Newport Harbor High School Narrative Changes – Mechanical Addendum 1

January 26th, 2021

Attention: Mr. Lance Bidnick
Project: Newport Harbor High School
Newport Beach, California 92663
Subject: Narrative Changes – Mechanical Addendum 1

SHEET NO:
MD-1.1

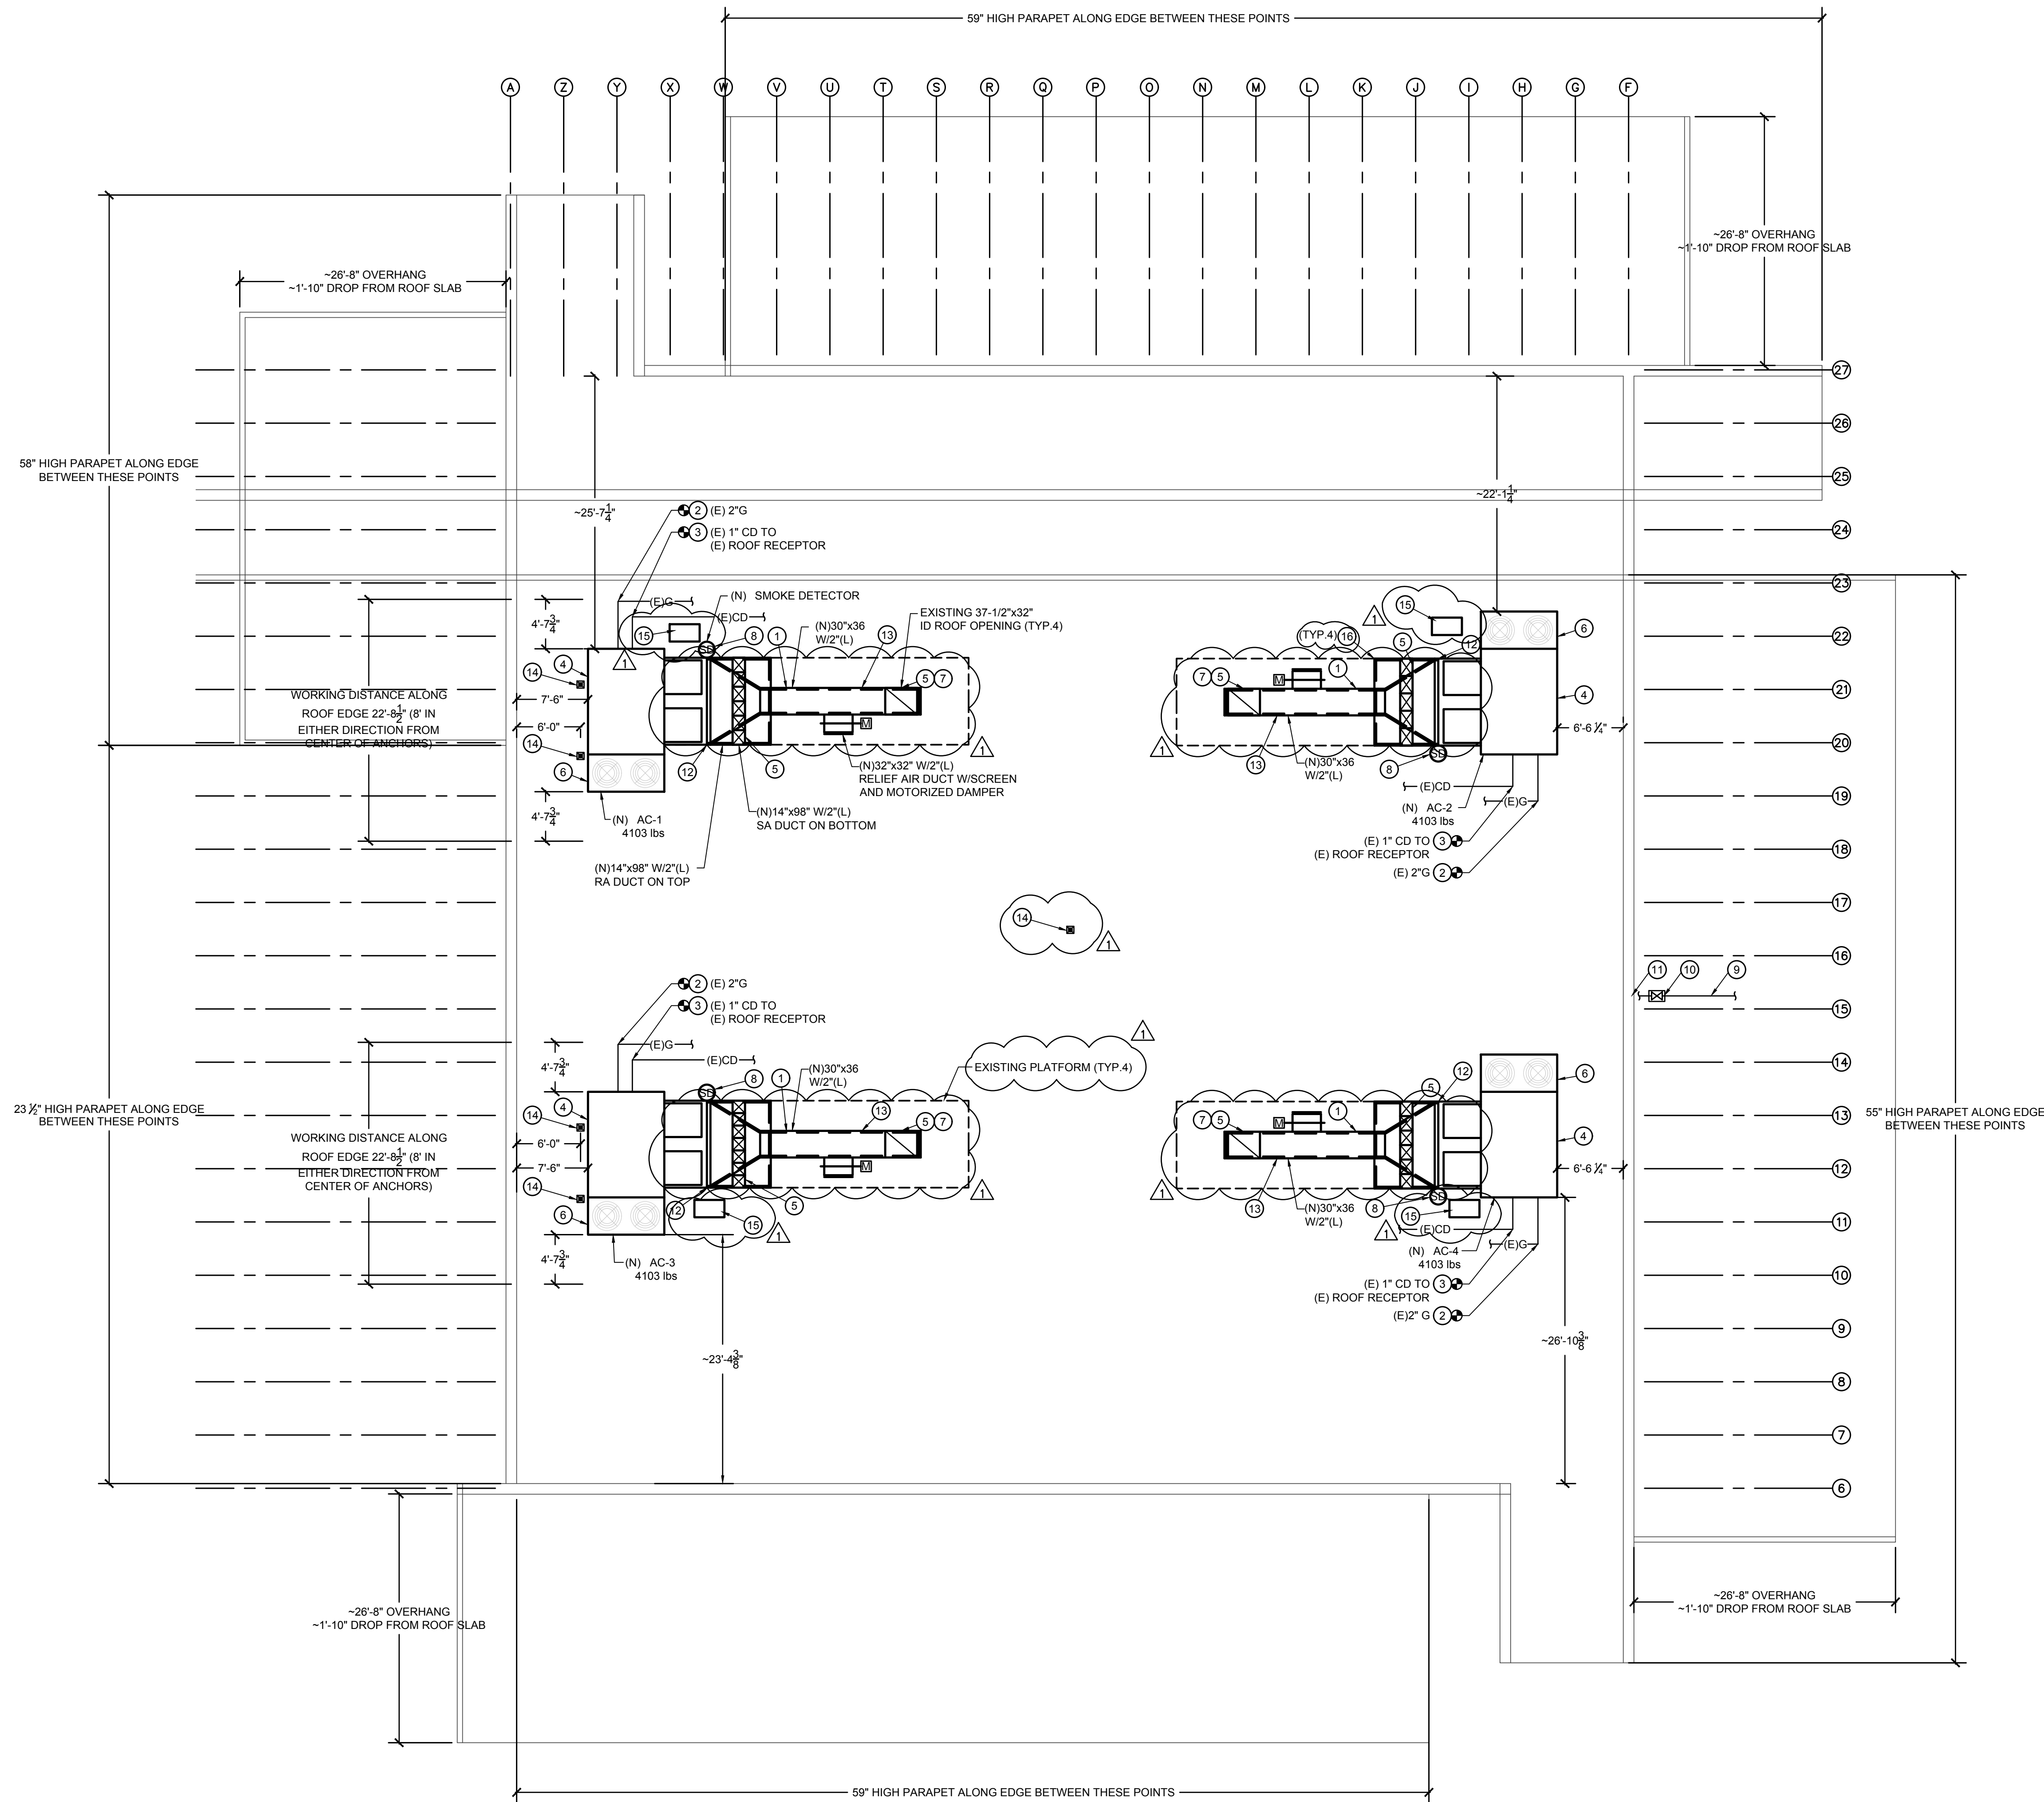
Sheet MD-1.1

1. Revised demo keynotes #3 & #4 specifying duct supports (return and supply) & platform to be replaced new. See delta 1 cloud.
2. Added electrical boxes and demo keynote #10 specifying enclosure for electrical pipes thru roof to be replaced new. See delta 1 cloud.
3. Added keynote #11 specifying existing platform for duct drops and supports to remain. See delta 1 cloud.
4. Added platform for duct supports on drawings. See delta 1 cloud.

SHEET NO:
M-1.1

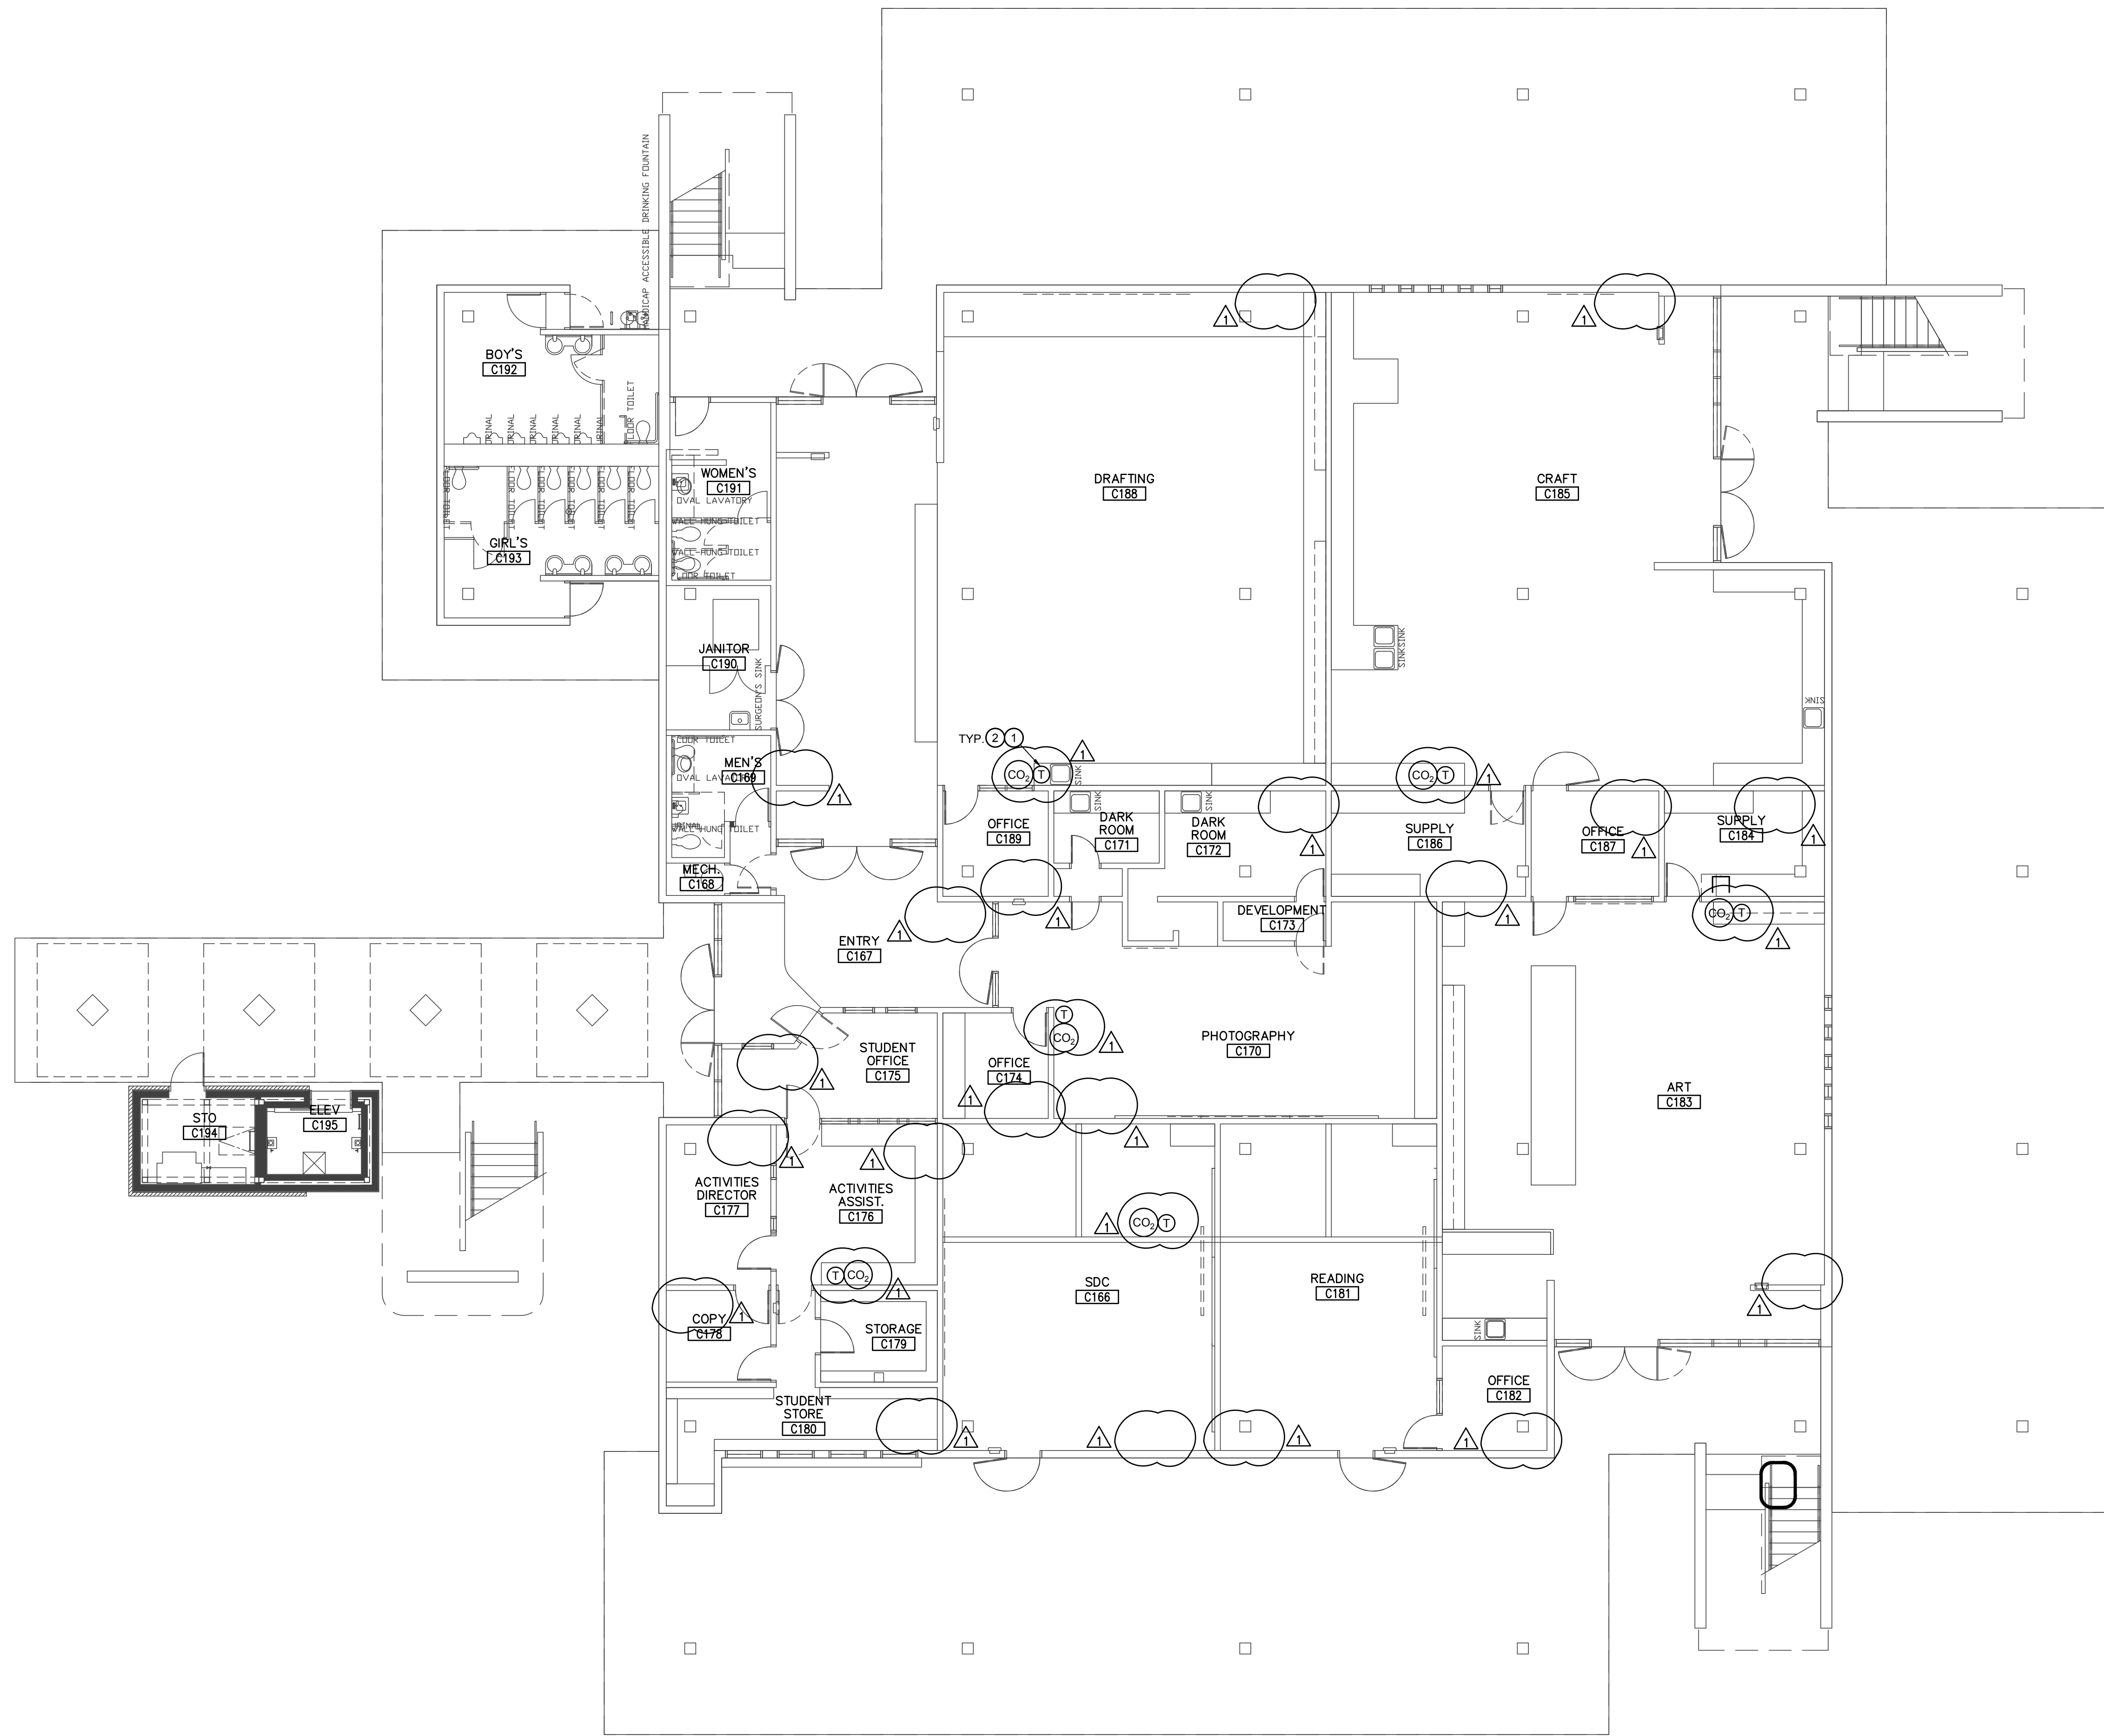
Sheet M-1.1

1. Revised construction keynote #1. Duct supports are specified as new instead of existing as it was shown previously. See delta 1 cloud.
2. Added One (1.no) fall protection device to center of roof. See delta 1 cloud
3. Added electrical boxes and construction keynote #15 specifying new enclosures for electrical thru roof penetrations to be provided. See delta 1 cloud.

4. Revised construction keynote #14 specifying TRM1200S as an alternative for fall protection.
5. Added construction keynote #16 to repair and finish platform for duct supports and drops see detail #4/M-2.3 provided.

(E) DUCT THROUGH ROOF DETAIL

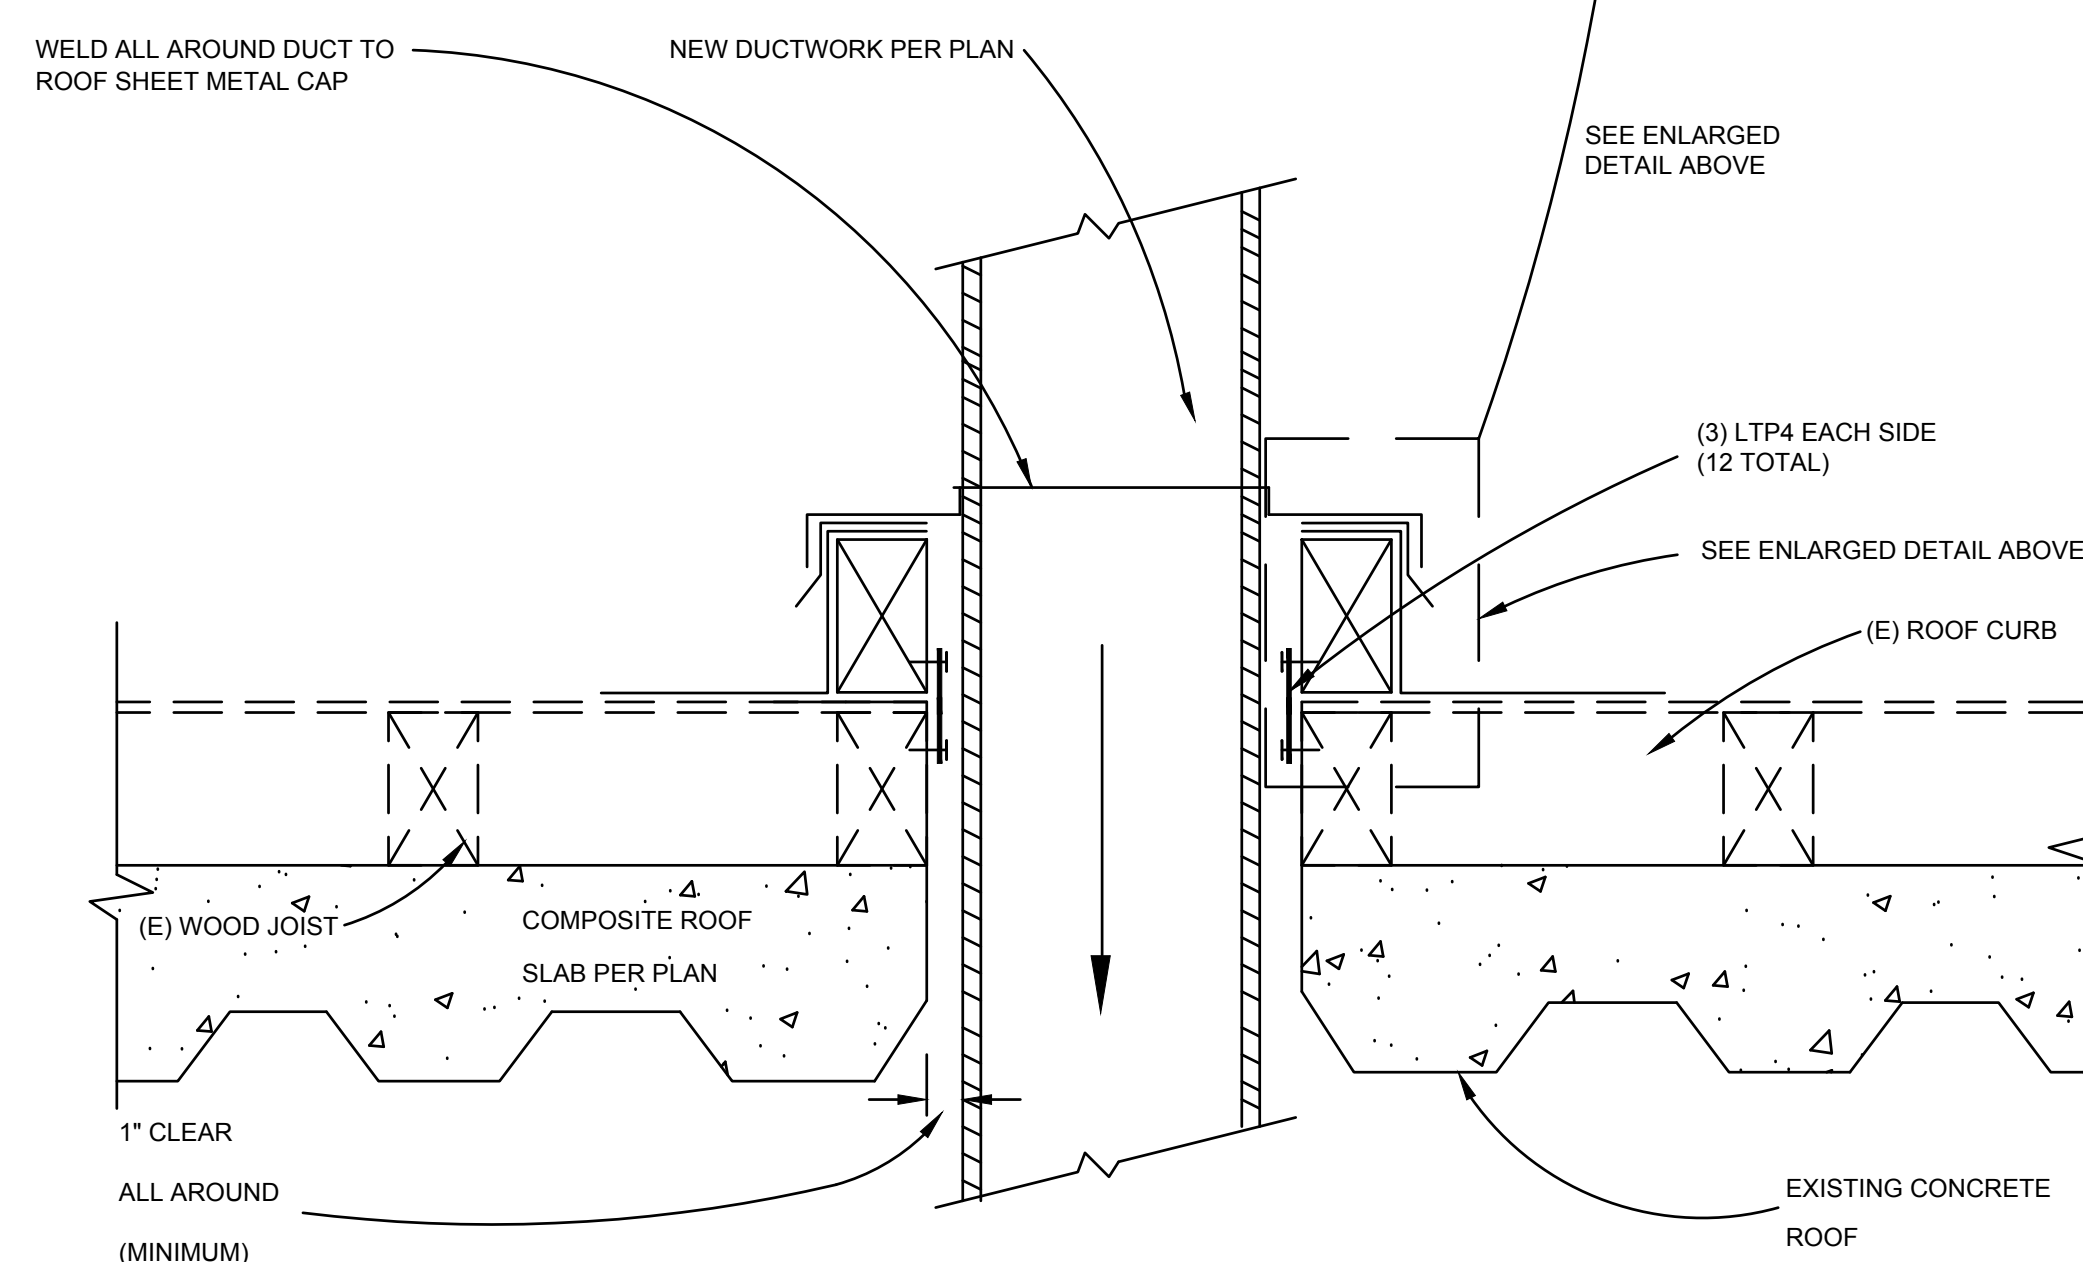
Detail F

9. Revised detail F to show existing roof platform and fastening to new curb and deck. Duct drops identified as existing added/included isometric view for flashing See delta 1 cloud
